**Committee:** Planning Committee  
**Date:** Thursday 8 September 2022  
**Time:** 4.00 pm  
**Venue** Bodicote House, Bodicote, Banbury, Oxon OX15 4AA

### 8. **Development Brief for Local Plan Partial Review site PR6a – Land East of Oxford Road, North Oxford** (Pages 10 - 170)

Figure 1: Development framework

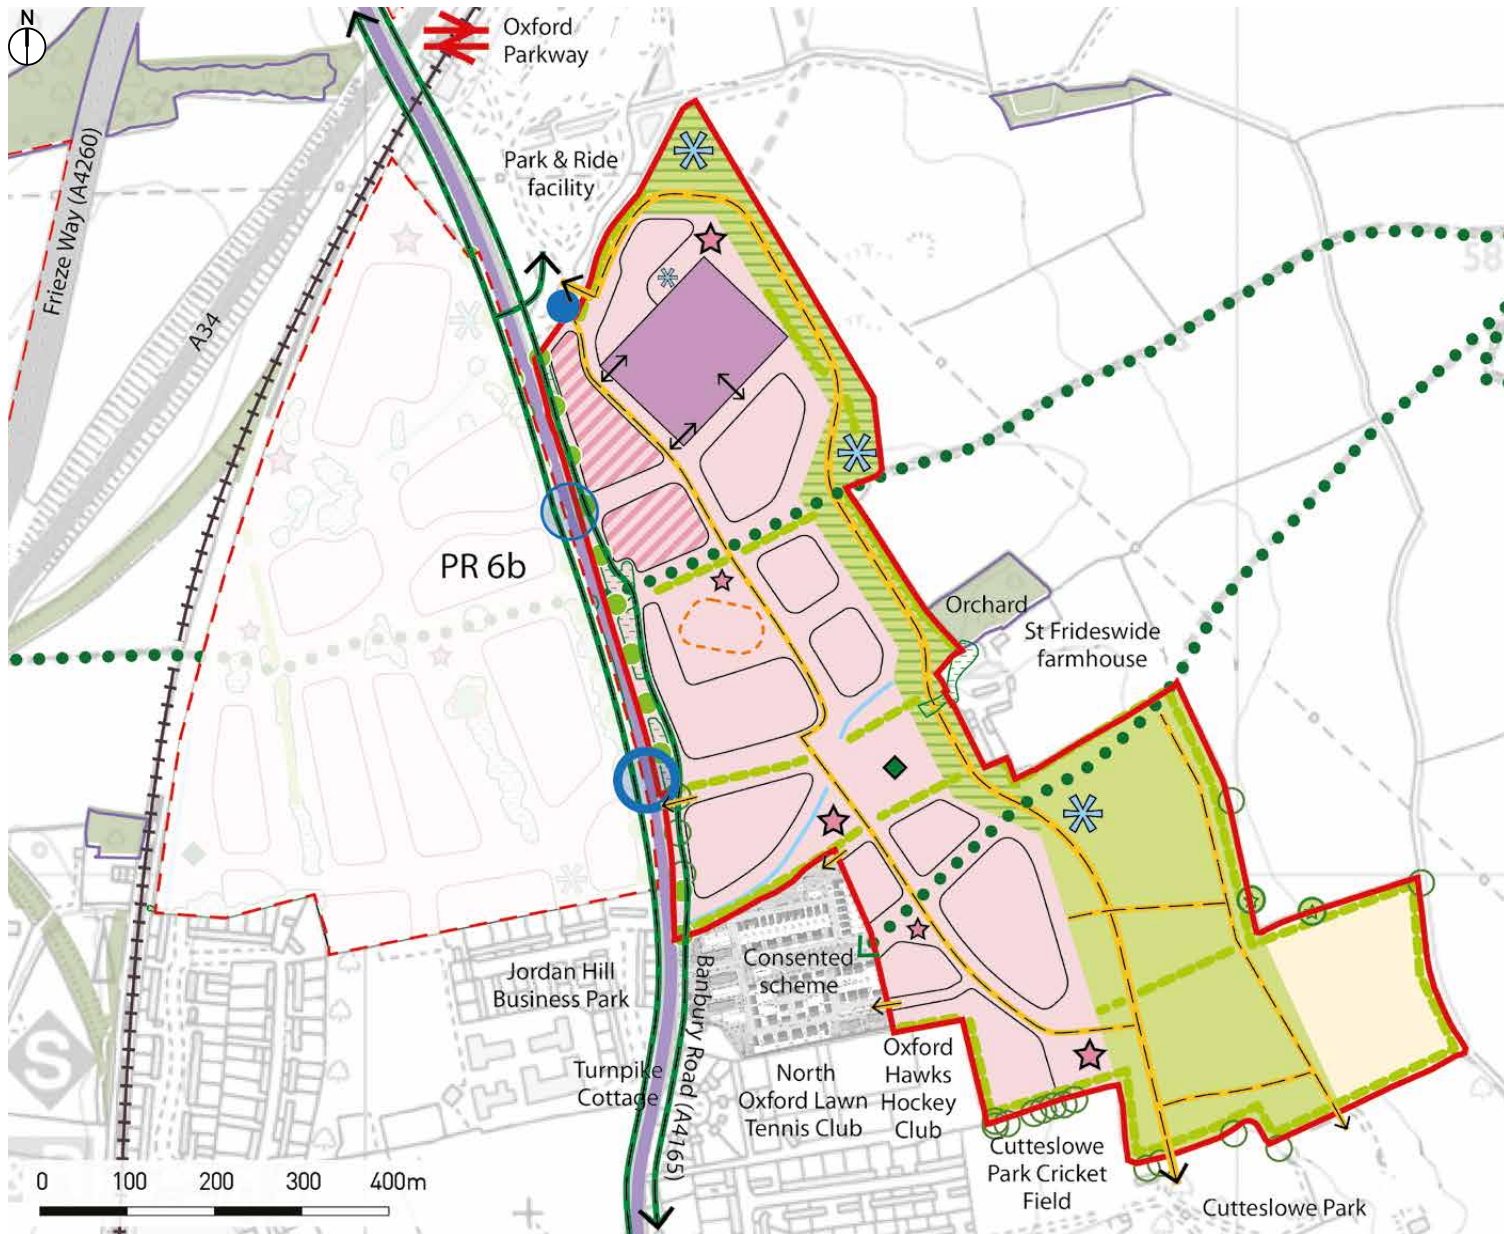
St Andrews Church Oxford	<p>Location of the primary school - Agrees with 6.6 of the DB that the local centre and primary school should be in close proximity to one another. Concerned, though, that the location indicated in Fig 1 does not follow through on this principle. The primary school is located too far north on the site. St Andrews questions whether there are errors in Figures 7 or 8 for the location of local centres and schools is wrong. The school and community building should be co-located but further south. Rather than (6.6) determining the school location solely by ref. to OCC school design requirements, the optimal location should be a response to a wider set of factors that may start with OCC education aspirations but must respond to community building, urban design and healthy place shaping principles.</p>	<p>Figure 8 shows the requirement of the adopted planning policy for the site, represented schematically in Fig 7. Neither of these figures is in error. Figure 1 does follow through on the principles set out in para 6.6 by locating the two uses in close proximity to one another. A central location would be preferable purely from an urban design perspective, but unfortunately the constraints presented by the site's changing levels, the archaeology and the extent of the developable area in the central location mean that a central location for these uses is not achievable without harming the archaeological remains or encroaching into the Green Belt. The northern location is not constrained in these ways and is also where the adopted planning policy shows the local centre to be located.</p>	None	n/a

<p>Savills (land promoter)</p>	<p>Figure 1 identifies two parcels of land for a 'mixed use' development, extending to about 2.5ha, whereas Policy PR6a requires the provision of a local centre on 0.5ha of land. The development brief should clarify what is meant by 'mixed use' compared to the 'local centre' policy requirement. The provision of allotments should be relocated and placed in more than one location where they integrate with the Green Infrastructure corridor and provide greater accessibility for residents of PR6a. (Also applies to Figs 12 and 13)</p>	<p>These areas have been shown indicatively, for discussion as to the best location. It is not envisaged that all of this mixed use land would remain in the final development brief, which would need to reflect the policy requirements for the site. Section 6.3.1 of the Development Brief states that "within the local centre, buildings will have a vertical mix of uses for example; ground floor retail and residential or office above. Front doors to upper floor uses are to be integrated into the active street frontage, rather than accessed via the rear." Mixed use is intended to mean that there will be residential use as well as local centre uses. It is evident, though, that 'mixed use' in Figure 1 may be misleading, so it will be replaced by the words "broad location for local centre". It is considered most appropriate (and efficient) for the allotments to be grouped together. Allotments in the location shown will help retain a sense of openness to the setting of St Frideswide's Farmhouse and will be next to the green corridor whilst being within the developable area as required by Policy PR6a. This location is within 800m of all parts of the site as required by Policy BSC11. It is not appropriate for the allotments to be sited in the green infrastructure corridor and there are different reasons (including space efficiency) for them not being dispersed around the site.</p>	<p>Figure 1 - change 'mixed use' to "broad location for local centre"</p>	<p>Figure 1, 13 and 15 key and amended from 'mixed use' to 'broad location for local centre'. Changes made to accompanying text at p57, second para; P57, development principles, second bullet; and P35 second column, 3rd bullet.</p>

- Figure 8 shows the requirement of the adopted planning policy for the site, represented schematically in Fig 7. Neither of these figures is in error. Figure 1 does follow through on the principles set out in para 6.6 by locating the two uses in close proximity to one another. A central location would be preferable purely from an urban design perspective, but unfortunately the constraints presented by the site's changing levels, the archaeology and the extent of the developable area in the central location mean that a central location for these uses is not achievable without harming the archaeological remains or encroaching into the Green Belt. The northern location is not constrained in these ways and is also where the adopted planning policy shows the local centre to be located.

- Figure 1, and Figures 12 onwards, show the layout for the site as required by the Development Brief. Figure 7 shows the indicative locations as set out in the Local Plan proposals map. The policy allows for "minor variations in the location of specific uses...where evidence is available".

- figure 1 - 'mixed use' has been changed to "broad location for local centre"
- figures 13, 15, 21 - a walking & cycling route has been added through the site from the northern vehicular egress point, along the main road through the site, between the LEAP and the allotments, down to the southern LEAP and connecting to the walking & cycling route already shown; and add that this additional walking & cycling route is included with the provisos that it does not impinge on the green infrastructure corridor, result in harm to archaeological remains or require other land uses to be moved such that they would encroach into the Green Belt.

Figure 4: Economic links

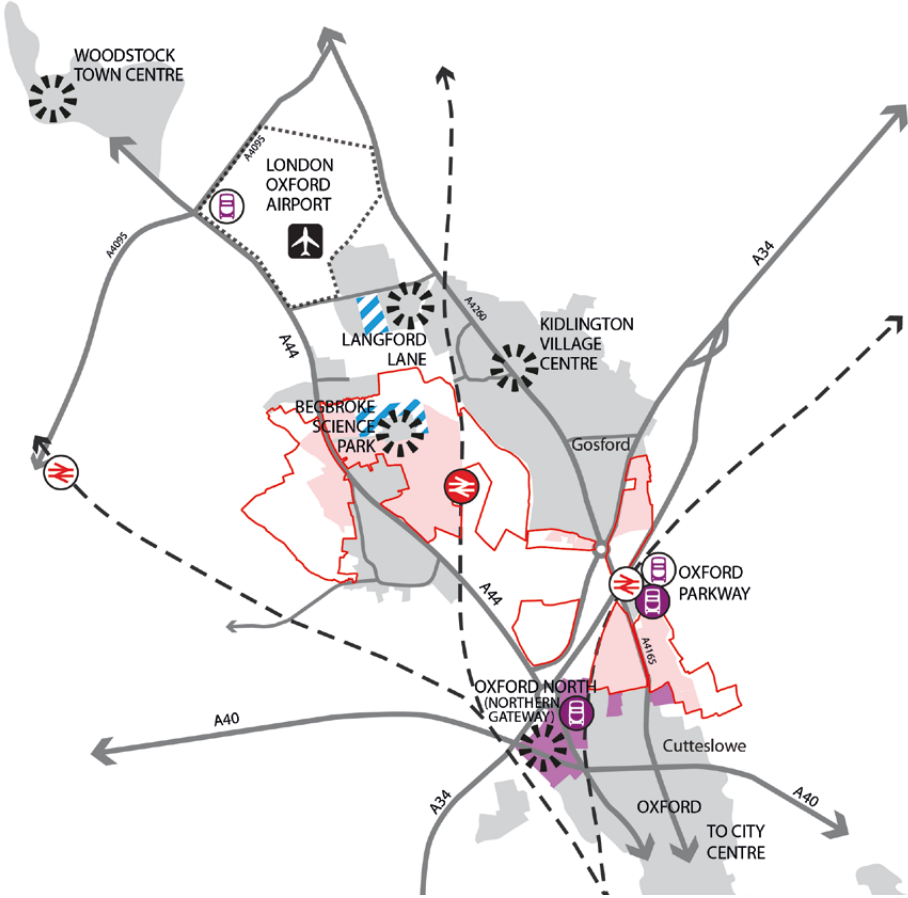
Savills (land promoter)	Figure 4 - There are inconsistencies in the figures and with other figures in the draft DB in terms of where the primary school is located. As stated in the land promoter's comments in relation to Figure 1, the school should be located centrally but that the caveat should be retained. Land South West of St Frideswide Farm (i.e. the site which is promoted by Croudace for 134 dwellings) should be included in these figures as being 'Proposed growth in adjoining local authorities'.	Figure 4 does not show the primary school and is not intended to. Figure 3 shows the primary school, but the location reflects the LPPR proposals map, as is the case for PR8. Fig 3 is caveated as being "for illustrative purposes only". The location of the school is discussed elsewhere in this spreadsheet.	None	
Savills (land promoter)	3.1.1 - Bullets 5 and 6: there is overlap with these areas, they are not separate areas – this should be clarified in the DB. Bullet 7: Add reference to the 3 hectares of agricultural land being 'retained'.	Bullets 5 and 6 reflect the Policy PR6a requirements. The landowner may wish to propose their amalgamation, but the policy lists them separately. Bullet 7 will be amended accordingly	Page 14, 7th bullet, the word "retained" to be added after "land"	Text changed

- Figure 4 does not show the primary school and is not intended to. Figure 3 shows the primary school, but the location reflects the LPPR proposals map, as is the case for PR8. Fig 3 is caveated as being "for illustrative purposes only". The location of the school is discussed elsewhere in this spreadsheet.

Figure 10: Site constraints

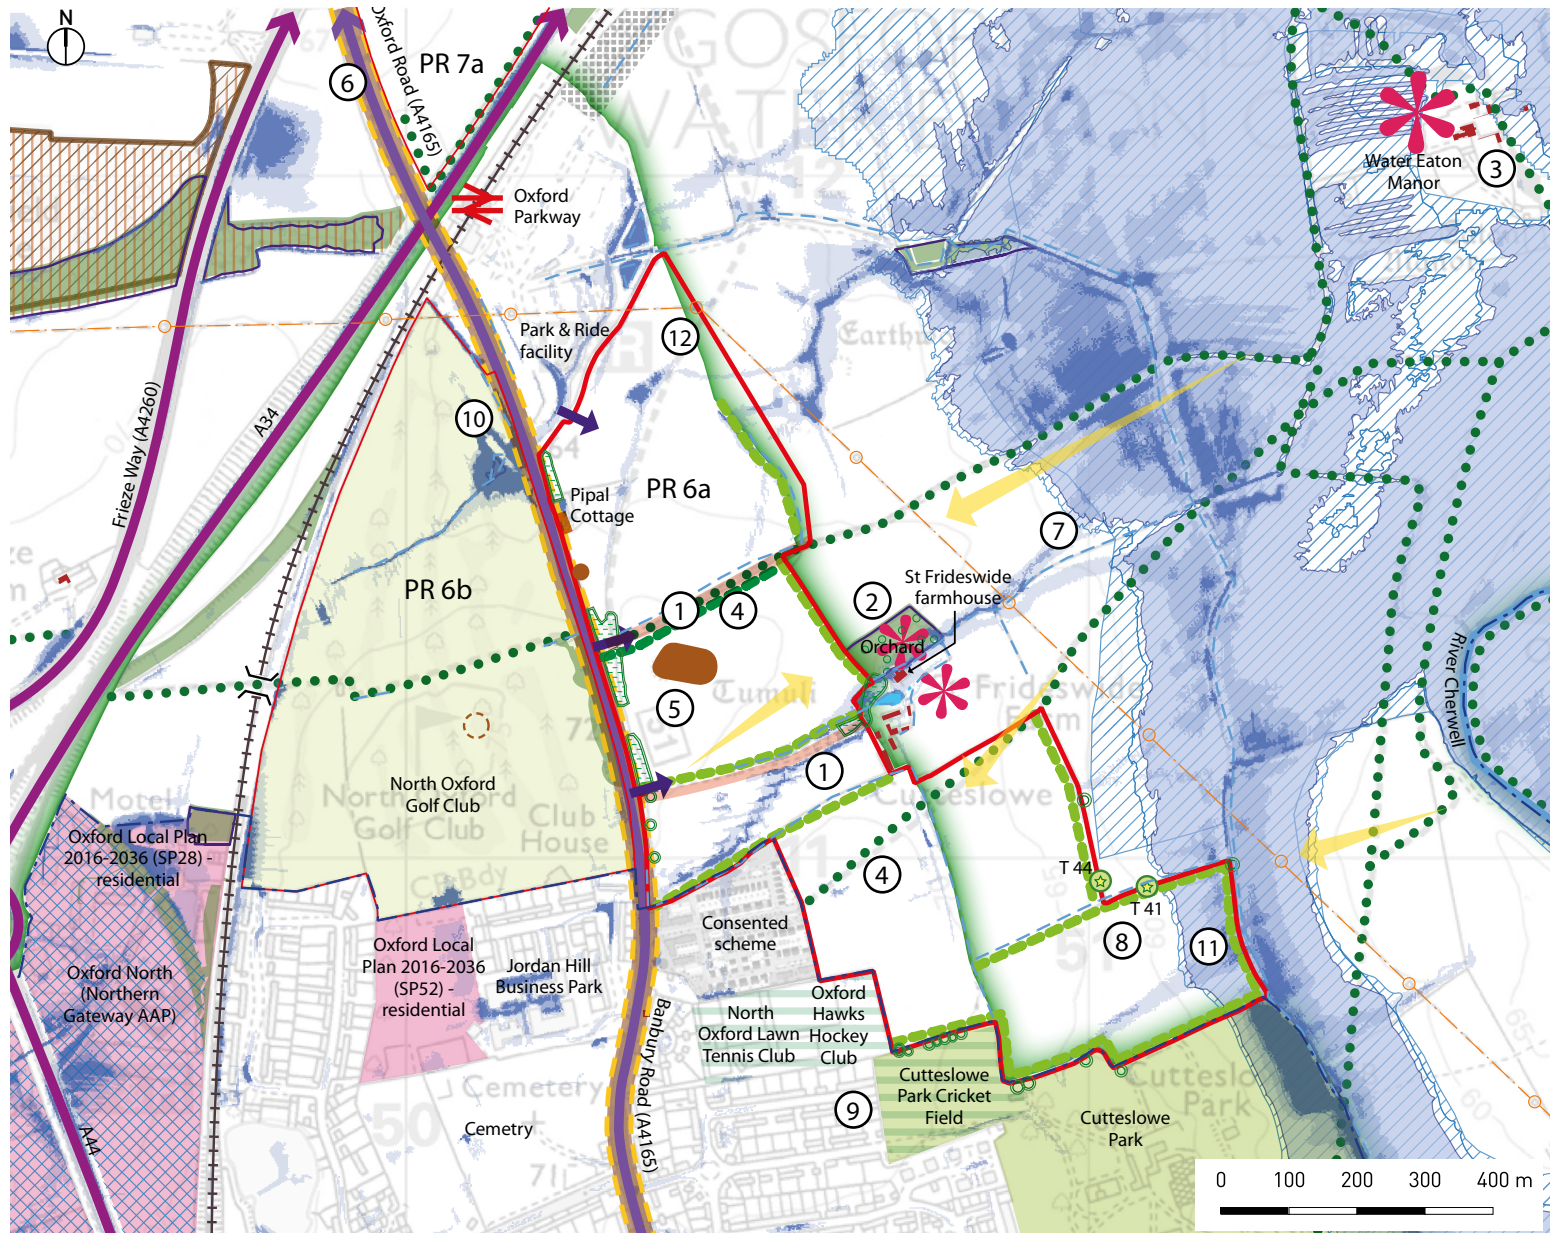
Savills (land promoter)	Figure 9: Site Context (Page 18) & 4.1 - Bullet 2, Target note 2 & Figure 10: Medieval Features: Recommend that the southern feature is amended or removed. It presently covers the barns associated with the listed farmhouse. None are medieval. If this symbol is intended to represent the location of the deserted medieval village or moated site, it should be moved further eastwards, approximately to where the 'St' of St Frideswide is located on each plan.	Noted. The appropriate change will be made.	The relevant figures and text to be amended accordingly.	Figures 9 & 10 amended by moving southern asterisk eastwards to the 'St'

Savills (land promoter)	<p>4.1 - Bullet 6, Target Note 6: The post-medieval milestone on Oxford Road appears no longer to be extant. Confirmation is required that this feature is still in place, otherwise this reference should be removed from the DB.</p>	Neither CDC or OCC has information to the contrary, so the Development Brief will be retained as drafted here	None	
Savills (land promoter)	<p>4.1 - Bullet 7, Target Note 7 / Figure 10: A 'High Sensitivity Viewpoint' is marked in the central field; however, this is identified on private land and not from any PRoW within the site. This viewpoint should therefore be removed from Figure 10. This is not followed through on to Figure 11, other than the reference to an 'important connection'. Importantly though, the desire to include views from new public realm to the landscape to the east is included within the DB.</p>	We note the point made but because views to and from listed buildings are important to its significance irrespective of the status of the land from which those views may be derived Figure 10 will not be amended	None

- We note the point made in relation to Figure 10, but because views to and from listed buildings are important to its significance irrespective of the status of the land from which those views may be derived Figure 10 will not be amended.

Figure 11: Site opportunities

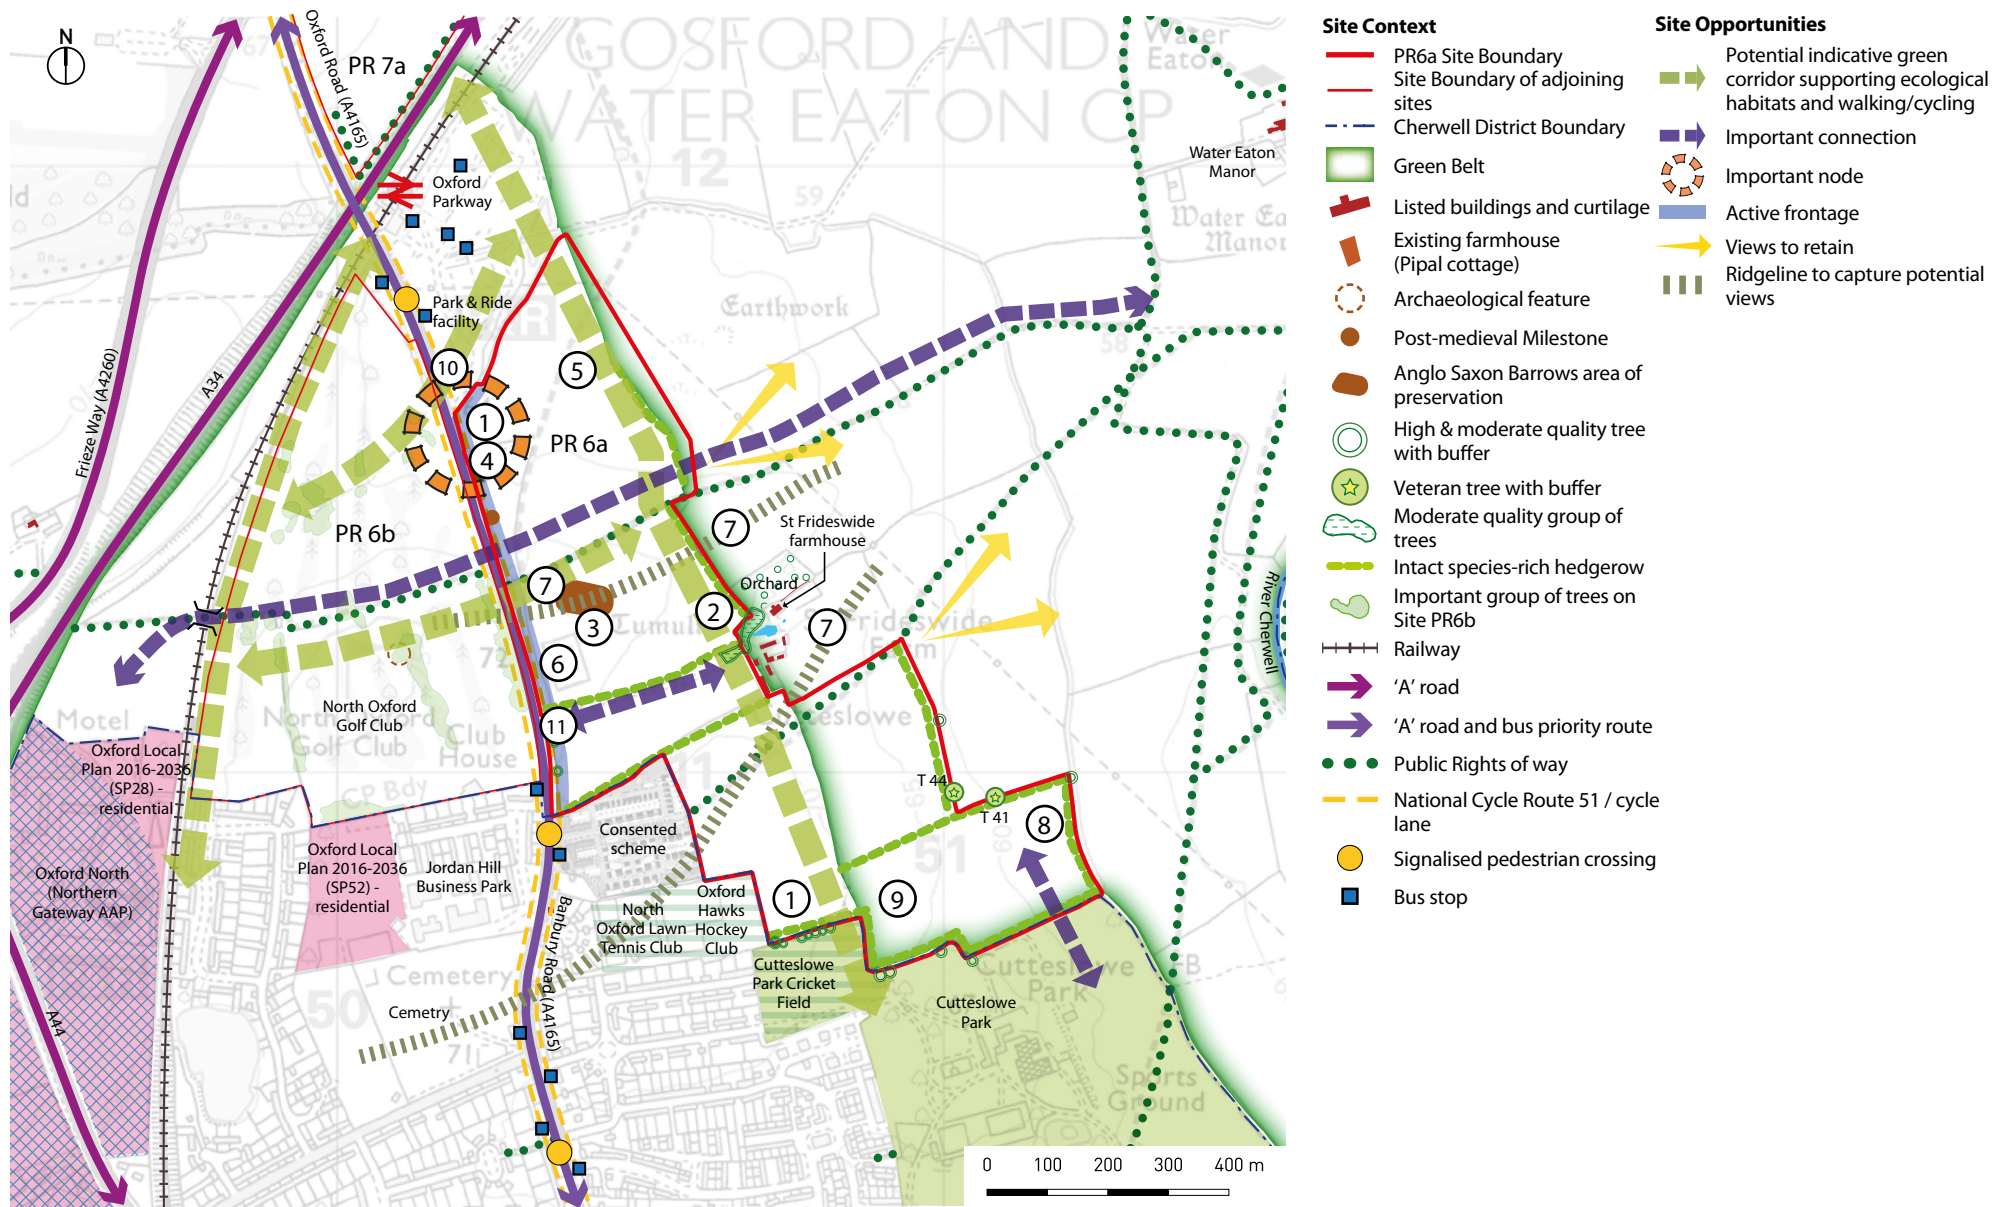
Savills (land promoter)	<p>Figure 11: Site Opportunities (Page 22)</p> <p>The 'important node' shown on this plan should be moved to the intersection between the junction on Oxford Road and the PRoW crossing the site. This position is where a movement node is created and it is the type of node which has often traditionally formed the centre of villages or market towns.</p> <p>Pipal Cottage and Barns are hidden by the number 4 target note reference icon. The annotation of St Frideswide Farmhouse on the plan is not well-related to the actual building shown on the plan. Suggest an arrow is used to point to the building itself.</p>	<p>It is not considered necessary or appropriate to move the 'important node'. It is noted that Pipal Cottage and Barns are hidden by the number 4 but if the latter was moved then other identified deficiencies would be true of the number 4. The annotation of St Frideswide is away from the actual building in order that it is not over other information, but it is a sensible idea to use to arrow to point to the building itself.</p>	<p>Figure 11 - Add an arrow to connect the words 'St Frideswide Farmhouse' to the building itself between the numbers 2 and 7.</p>	<p>Arrow to Fig 11 added</p>

- Re Figure 11, it is not considered necessary or appropriate to move the 'important node'. It is noted that Pipal Cottage and Barns are hidden by the number 4 but if the latter was moved then other identified deficiencies would be true of the number 4. The annotation of St Frideswide is away from the actual building in order that

- Section 4.2.2, bullet 5 - add the words "(Pipal Cottage) and/or barns" prior to 'within the new development'
- Figure 11 - Add an arrow to connect the words 'St Frideswide Farmhouse' to the building itself between the numbers 2 and 7.
